PUBLIC NOTICE

Notice is Hereby Given that the Tooele City Council and the Tooele City Redevelopment Agency will meet in a Work Meeting, on Wednesday, June 15, 2022, at 5:30 p.m. The Meeting will be Held in the Tooele City Hall Council Chambers, Located at 90 North Main Street, Tooele, Utah.

Crestview Development Zoning Map Amendment

To: City Council
CC: Planning Commission
From: Mayor Debra E. Winn, City Administration
Date: January 19, 2021
Re: Administrative Recommendation for Canyon Springs Annexation

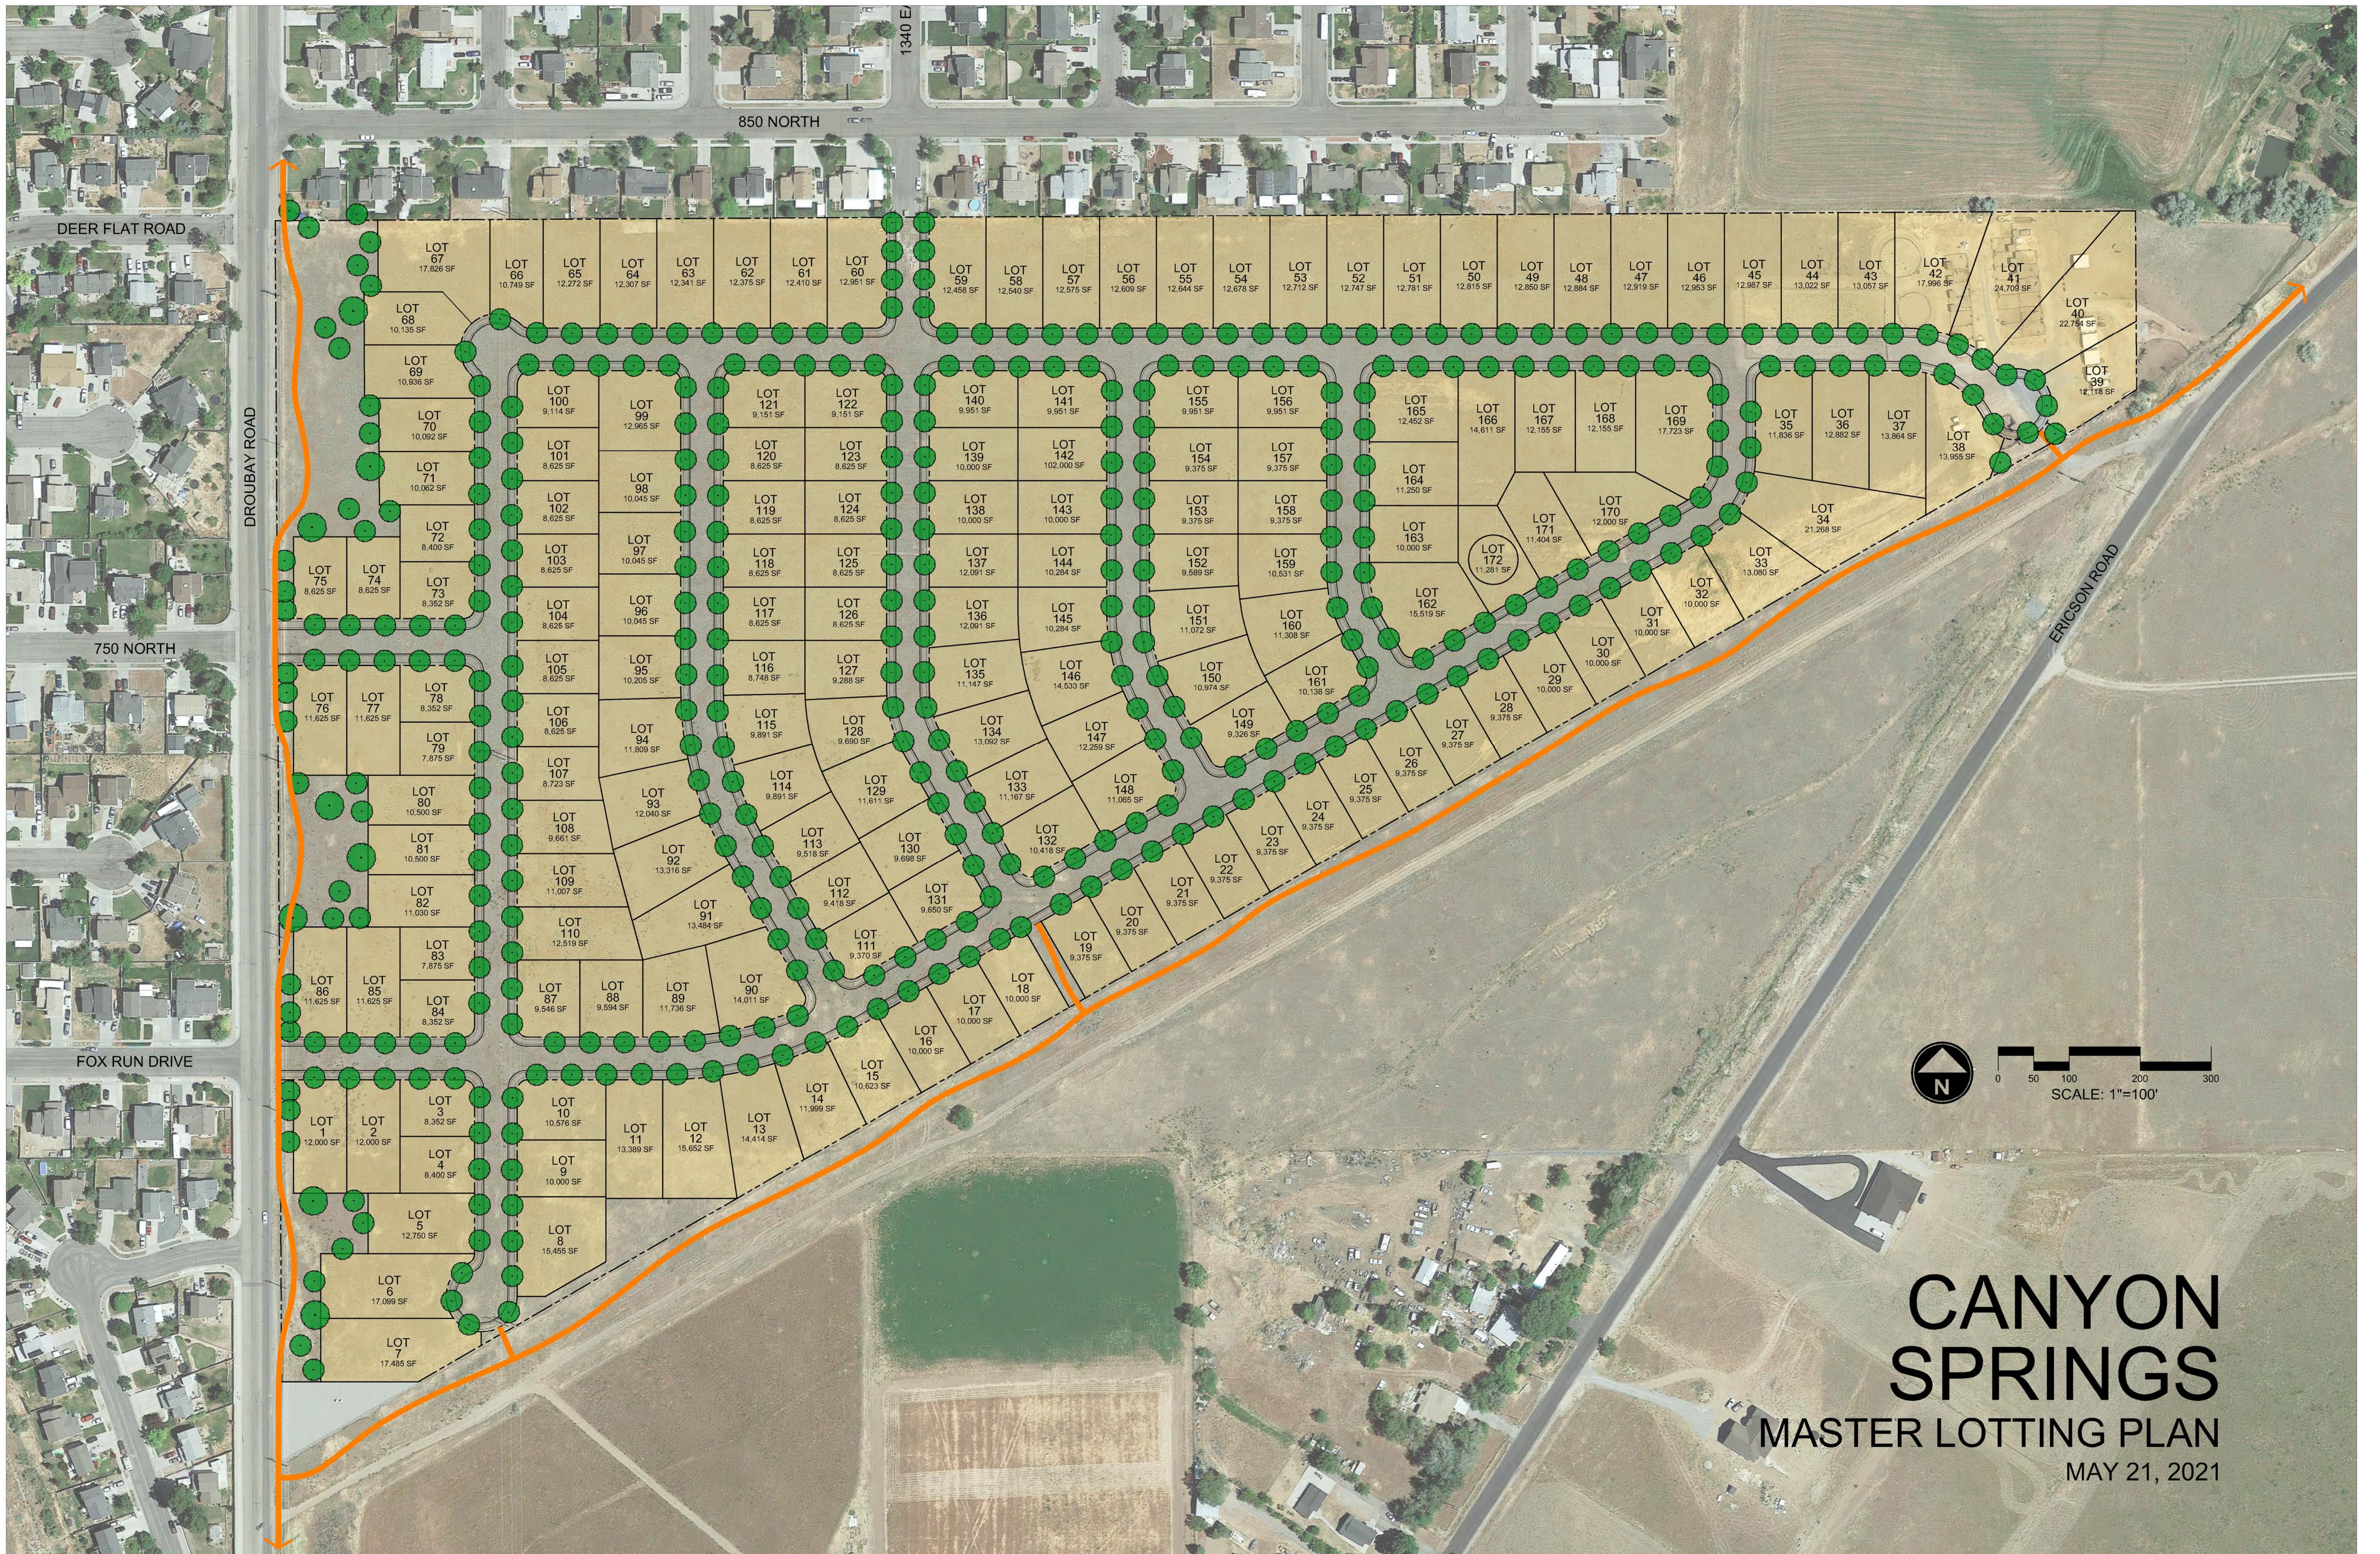
plat, and outside Canyon Springs (the Canyon Springs concept plan is enclosed). The Trail in this location would be low-functioning because it is located outside Canyon Springs, leads to no connecting or proposed trails in the City or the County, and is isolated from public visibility, where it would tend to invite increased criminal conduct. Instead, the City Administration proposes that Canyon Springs incorporate a looped trail on the development interior, thus being more visible and accessible to the residents, and being looped rather than a dead end. The Trail should be maintained by an HOA. Additional benefits of the Trail in this location and configuration are discussed in #4, below. Should the City Council favor the Trail as depicted in the Canyon Springs concept plan, we recommend that the Trail Land first be included in expansion area K of the City's Annexation Growth Plan, be included in an amended annexation petition, be deeded to Tooele City, and be improved, as express conditions of the Annexation.

4. Storm Water Detention. We disfavor the three storm water detention areas on Droubay Road as depicted on the Canyon Springs concept plan. They are disconnected and fragmented, they would be ineffective at serving their intended purpose, and they appear to be strategically located to avoid the City's double-frontage lot right-of-way improvements. Similarly, we disfavor a single large detention area on Droubay Road at the northwest corner of Canyon Springs. Instead, we recommend that storm water detention be a series of detention facilities ("Facilities"), designed to accommodate the natural or built topography. The Facilities should be multi-functional, integrated into the internal looped Trail, and designed to be community amenities. The detention areas should include vertical recreational improvements (e.g., play equipment, exercise equipment, benches, pavilions) in order to maximize their multi-functional purpose. As part of the Trail, the Facilities should be maintained by an HOA.

6. Park Strip Landscaping. Grassed five-foot park strips are recognized as inefficient water uses. We suggest that Canyon Springs represent a change in City park strip landscaping standards away from turf grass and toward lower water usage. To that end, we recommend that Canyon Springs park strips be landscaped with drip-irrigated xeriscaping, of a professional design acceptable to the City, using specific approved tree species. In the alternative, we recommend a park strip width of eight (8) feet in order to increase irrigation efficiencies, increase snow storage capacity, and reduce conflicts between trees and concrete. All uniform park strip landscaping would be maintained by an HOA. The Droubay Road frontage should comply with the City’s double-frontage lot standards, found in TCC Chapter 7-19, including a masonry wall, all HOA-maintained.
